From:
Sent: 09 March 2026 15:33
To: DC Admin
Subject: Planning Application 2025/90033 - Erection of 11 dwellings adj 916 Halifax Road
Attachments: Planning 090326-1.pdf; Damaged wall & temporary fence.jpg; nonmaintained1.jpg; nonmaintained2.jpg; nonmaintained3.jpg; Plot 2 boundary.jpg

As I am unable to comment on the above application directly inside the planning portal I write separately with my **objection**. I've have attached six files to support my concerns as below.

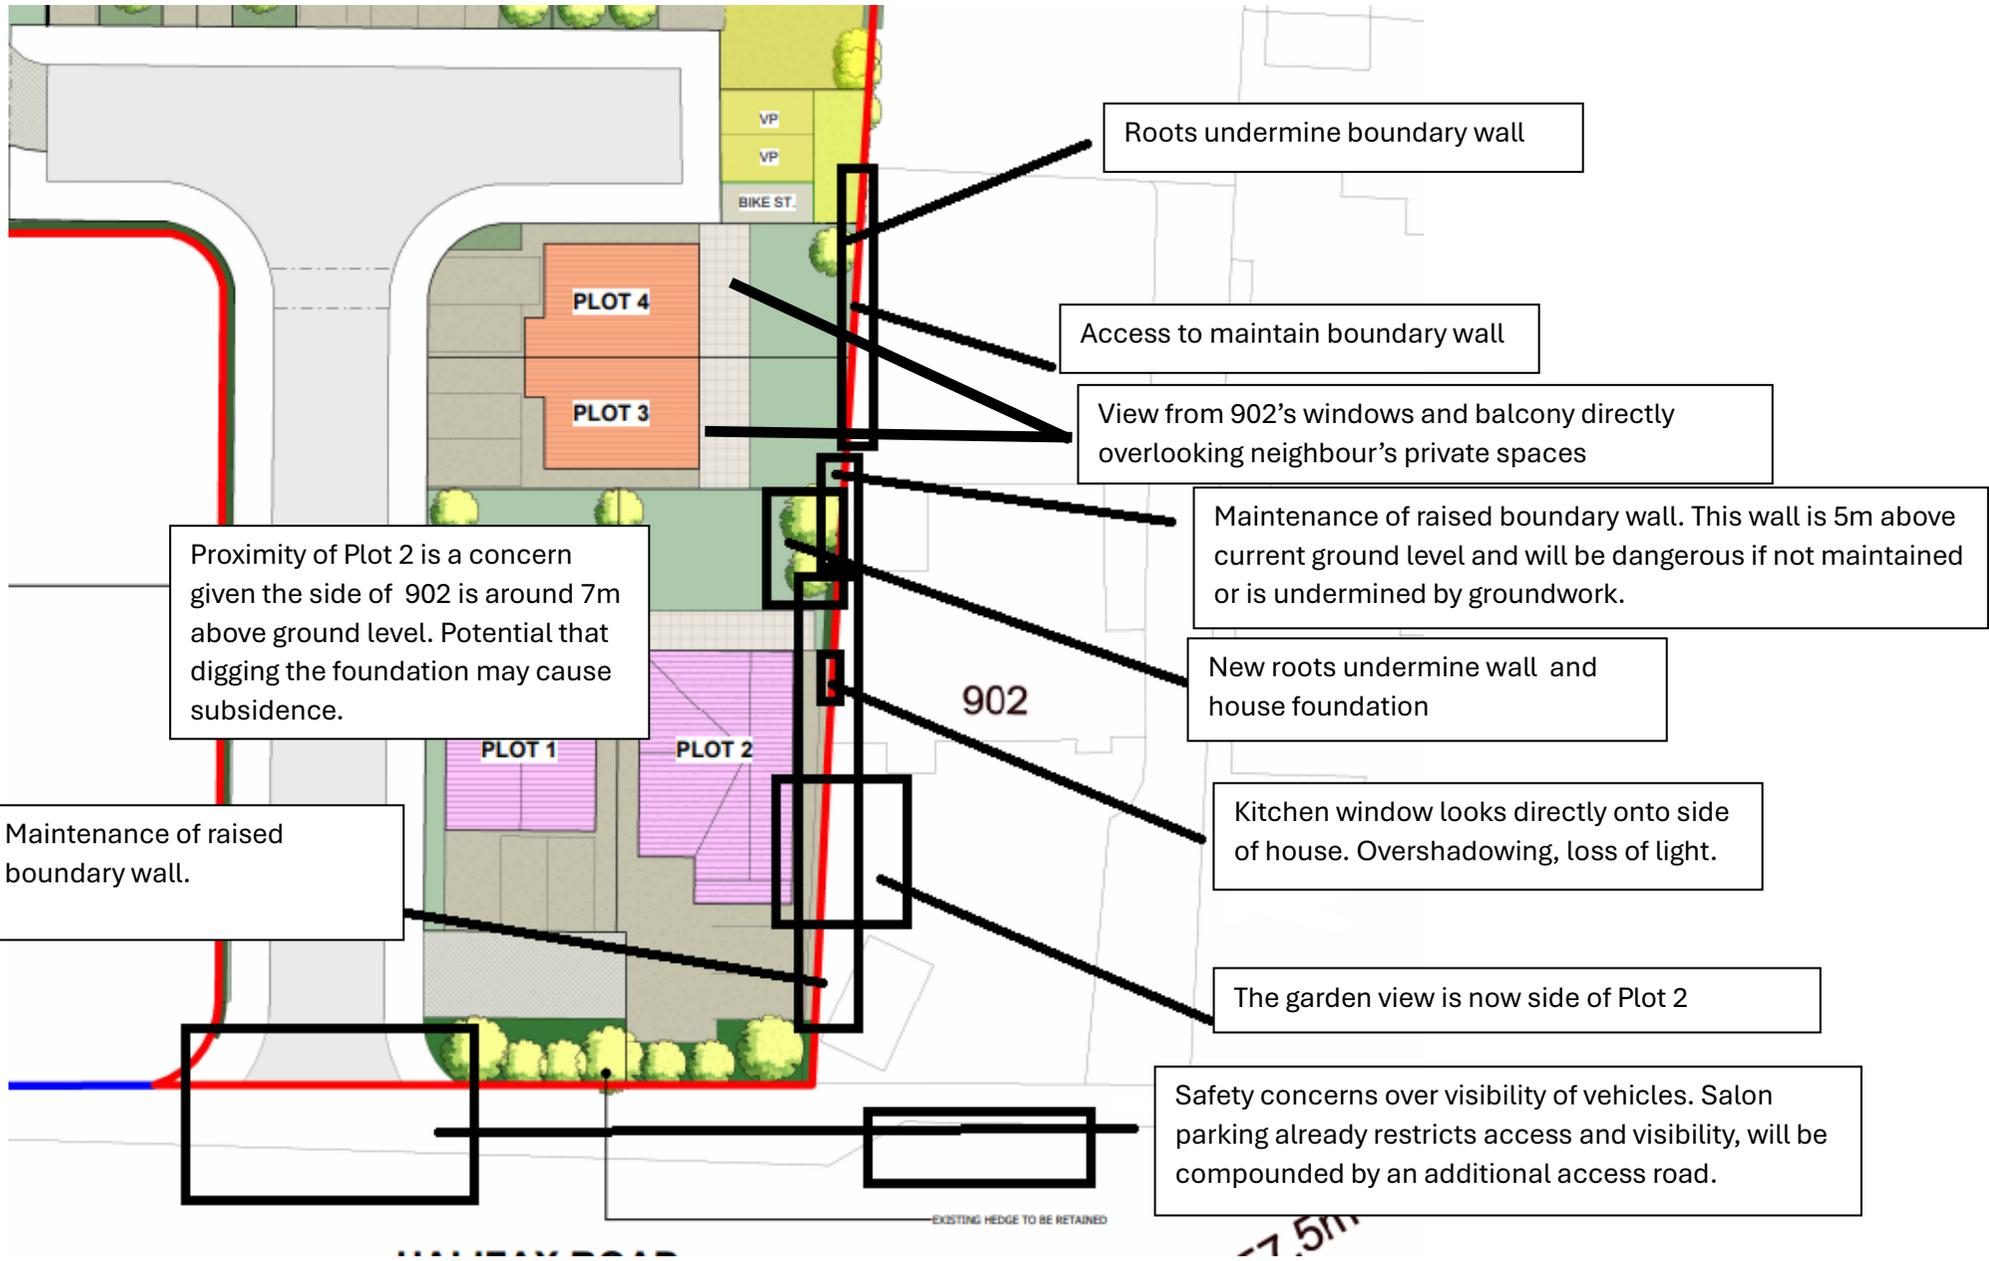
Roots undermine boundary wall

Access to maintain boundary wall

View from 902's windows and balcony directly overlooking neighbour's private spaces

Maintenance of raised boundary wall. This wall is 5m above current ground level and will be dangerous if not maintained or is undermined by groundwork.

New roots undermine wall and house foundation

Kitchen window looks directly onto side of house. Overshadowing, loss of light.

The garden view is now side of Plot 2

Safety concerns over visibility of vehicles. Salon parking already restricts access and visibility, will be compounded by an additional access road.

Proximity of Plot 2 is a concern given the side of 902 is around 7m above ground level. Potential that digging the foundation may cause subsidence.

Maintenance of raised boundary wall.
